Subject: Re: Email 2: Fire safety requirements for planning condition discharge at Bartlett Close (formerly Bartlett House) Ludgershall, Andover SP11 9SA
Date: Wednesday, 21 January 2026 at 13:58:46 Greenwich Mean Time
From: Thomas Bath
To: Marton, Simon, Matthew Williams
CC: Kalvis, Michael, andrew.allan@proairconsultants.co.uk, Ben Mees, Joe Edgard
Attachments: image001.png, image002.png, image003.gif, image004.png, image005.png, image006.png, image007.jpg, image008.png, image009.png, Outlook-4x4yn4g.jpeg

Subject: RE: Email 2: Fire safety requirements for planning condition discharge at Bartlett Close (formerly Bartlett House) Ludgershall, Andover SP11 9SA

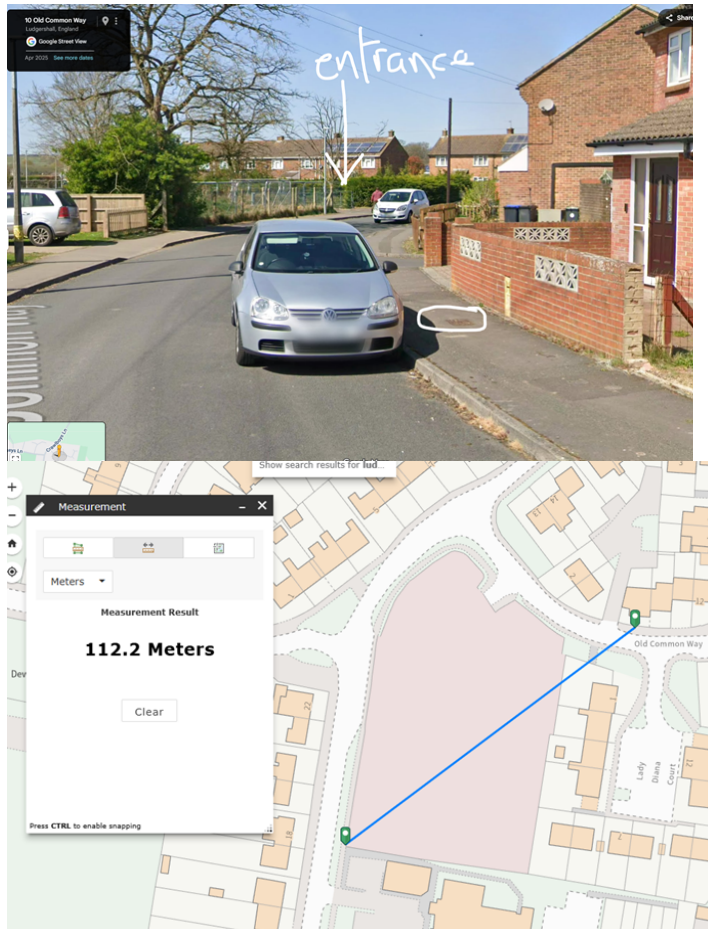
Firstly the proposed hydrant location doesn't marry up with the mains drawing, and with the distances the measurement should be an 'as walked' measurement as opposed to 'as the crow flies'. This is to ensure the hydrants are within a suitable operation distance to the furthest point of the site.

Our nearest hydrant on Old common way would not satisfy this distance at 130m. Granted AD B doesn't specify for dwellings however guidance suggests similar distances as specified in AD B (non-dwellings) of 90m.

I would accept a fire hydrant as detailed in the drawing, near to plots 3/4, in the footway however, the main to the hydrant would need to be increased to a minimum of 90mm in order to supply the required flow rates. This requirement would need to be met by the developer.

Would it be possible to check that you are happy with the current fire hydrant proximity to the site and that when connected to an appliance, the reach is sufficient to the far end of the site... Am I correct that in the second snip showing the 112m distance that it would actually be acceptable as the appliance reach has not been taken into account?
